# 2d Read and Vote Manual Language for Hybrids Phase 1a – Manual 14D and Manual 10

Andrew Levitt  
Senior Lead Market Design Specialist,  
Market Design and Economics Department  
PJM Operating Committee  
August 11, 2022

Manual 10: Pre-Scheduling Operations, Revision 60  
Manual 14-D: Generator Operational Requirements Revisions, Revision 60

### Section 4.2.3 Metering for Individual Generators

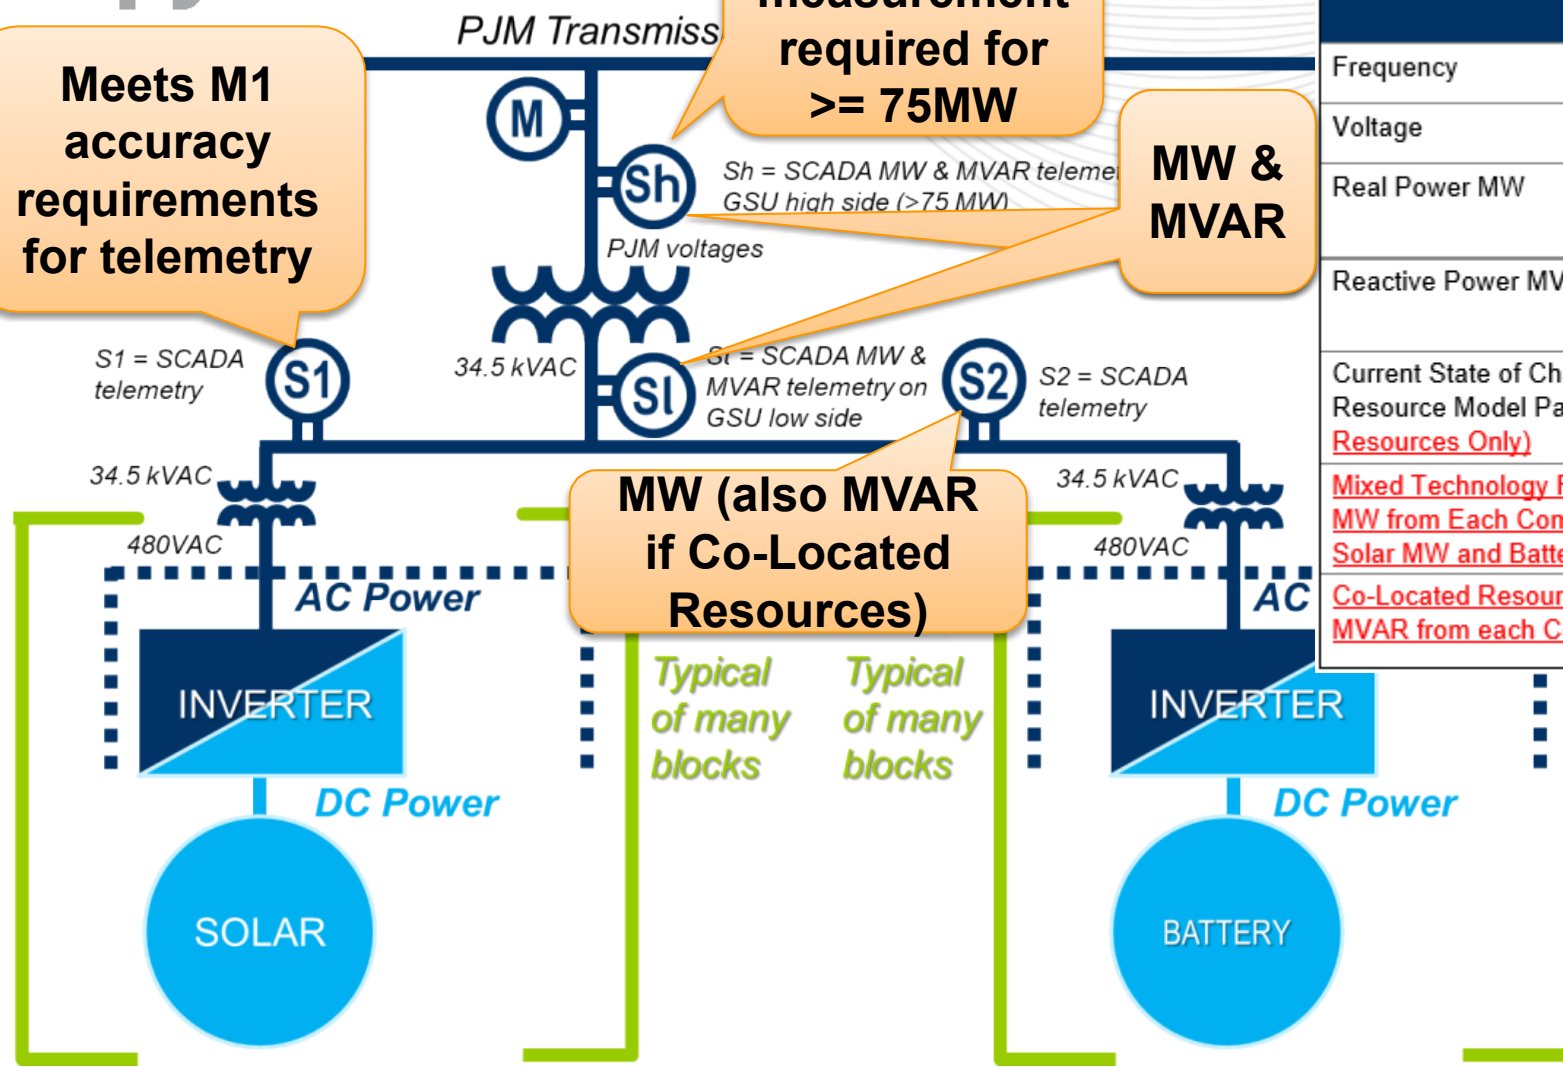
Meets M1 accuracy requirements for telemetry

Real Time Instantaneous Data Sent To PJM	
Frequency	1/1000th of HZ (i.e. 60.001 Hz)
Voltage	1/10th of kV (i.e. 69.1 kV)
Real Power MW	1 MW integer (i.e. 52 MW) required, but PJM will accept greater precision if available
Reactive Power MVAR	1 MVAR integer (i.e. 42 MVAR) required, but PJM will accept greater precision if available
Current State of Charge (Energy Storage Resource Model Participants <u>and Hybrid Resources Only</u> )	MWh remaining
<u>Mixed Technology Facilities Only—Real Power MW from Each Component Technology (e.g., Solar MW and Battery MW).</u>	<u>1 MW integer (i.e. 52 MW) required, but PJM will accept greater precision if available</u>
<u>Co-Located Resources Only—Reactive Power MVAR from each Co-Located Resource</u>	<u>1 MVAR integer (i.e. 42 MVAR) required, but PJM will accept greater precision if available</u>

Exhibit 15: Example of inverter-based AC-coupled open-loop Hybrid Resource with 100 MW solar and 40 MW battery.

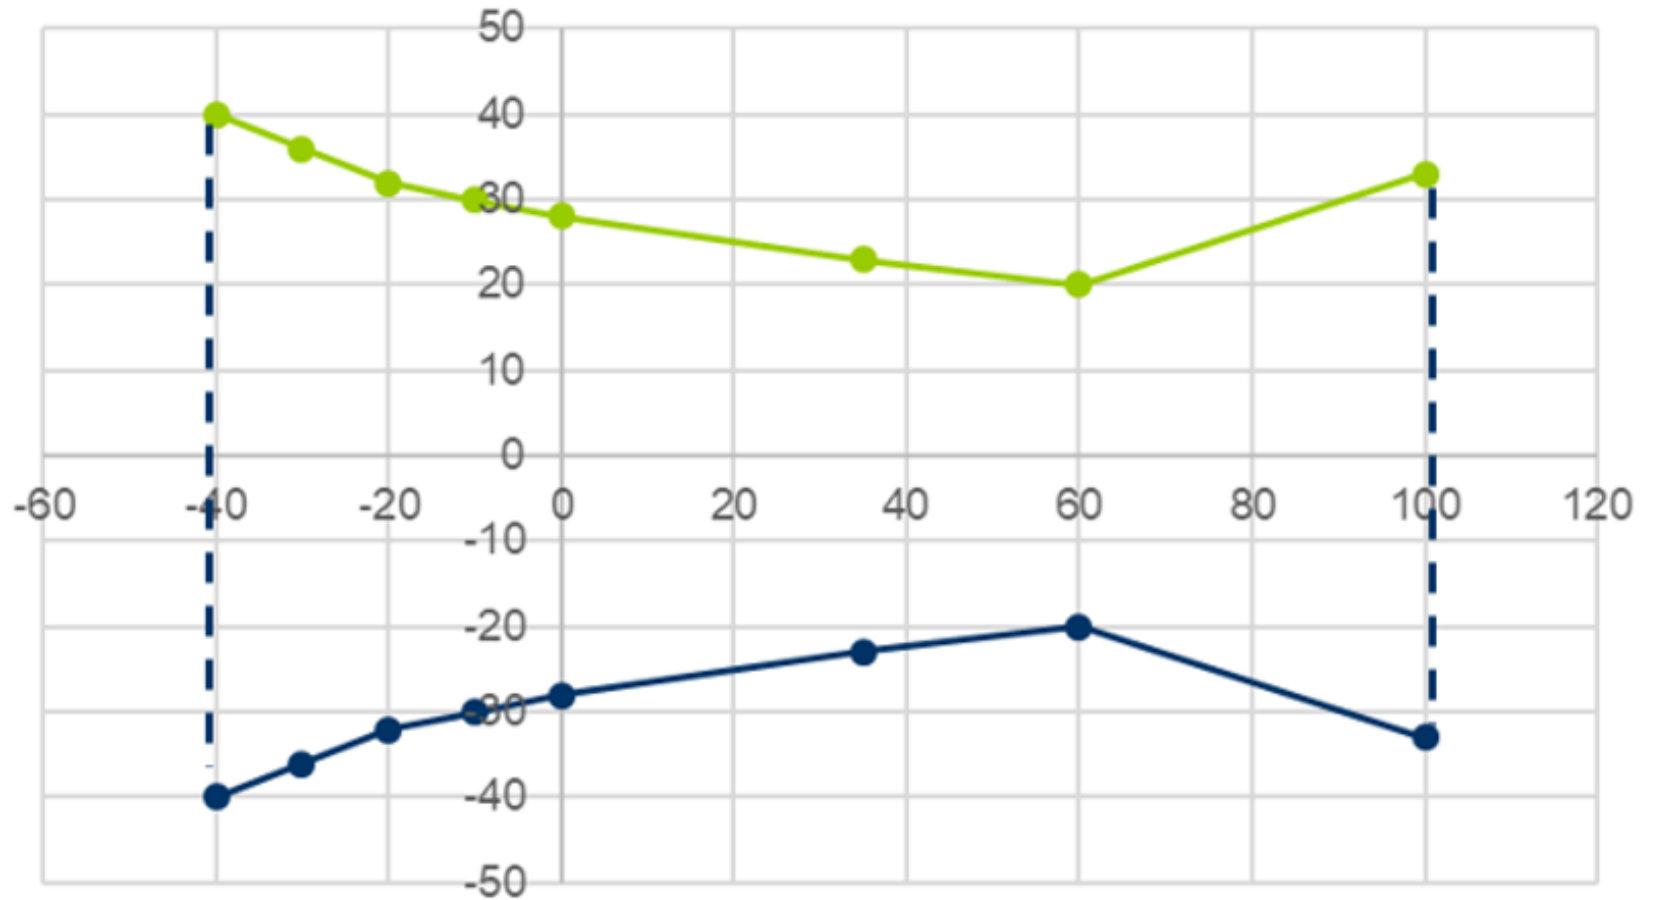
An AC-coupled Hybrid Resource has two (sets of) electrical machines (i.e., inverters), and so shows a D-curve that reflects conservative conditions.

In particular, for the solar to feed the battery, both the solar inverters and the battery inverters need to do an AC power conversion. This leaves less inverter capability available for reactive.

10. For a Hybrid Resource consisting entirely of inverter-based components, a single D-curve is tested. Such facilities are tested consistent with the provisions for inverter-based Hybrid Resources specified in the table “TESTING REQUIREMENTS SUMMARY” in Attachment E below.
11. For a Mixed Technology Facility participating in markets as multiple Co-Located Resources, multiple D-curves are tested (one D-curve for each unit at the site). For a Mixed Technology Facility not consisting entirely of inverter-based resources, one D-curve may be tested for each unit at the site.
12. For a Hybrid Resource, the composite reactive capability curve shall represent the most conservative capability of the combined Generating Facility at each net MW injection point. See examples in Figures 15 & 16 below.

Figure 16: Example of inverter-based DC-coupled open-loop solar-storage Hybrid Resource with 100 MW solar and 100 MW battery.

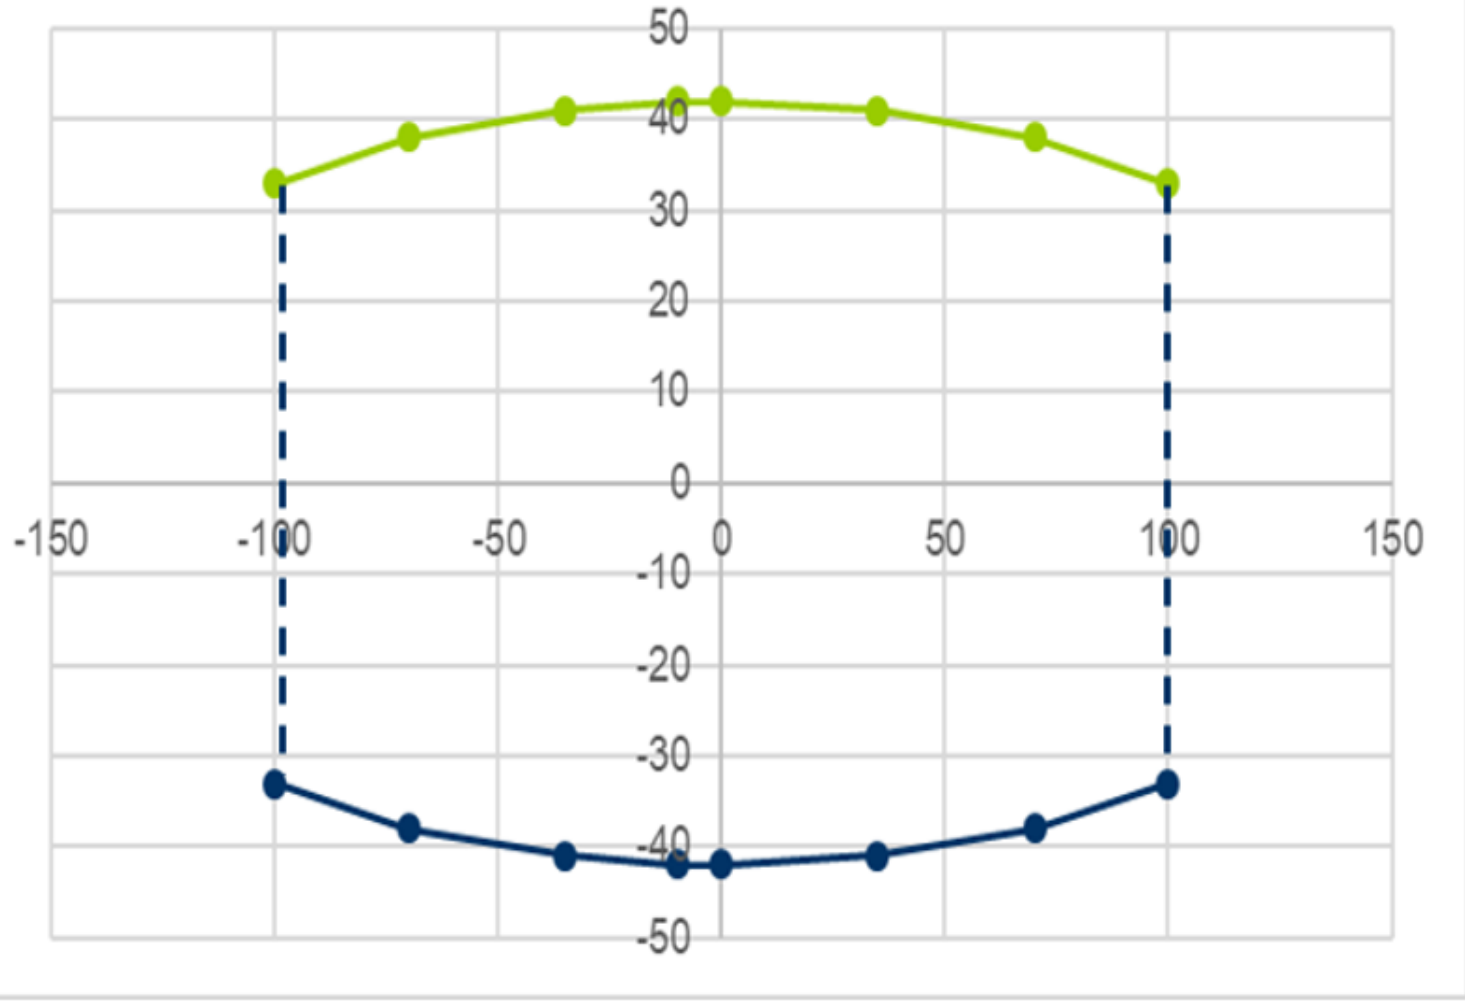
A DC-coupled Hybrid Resource has a single (set) of electrical machines (i.e., inverters), and so shows a more typical D-curve.

In particular: the solar would feed the battery directly, without needing AC power conversion. This leaves more inverter capability available for reactive.
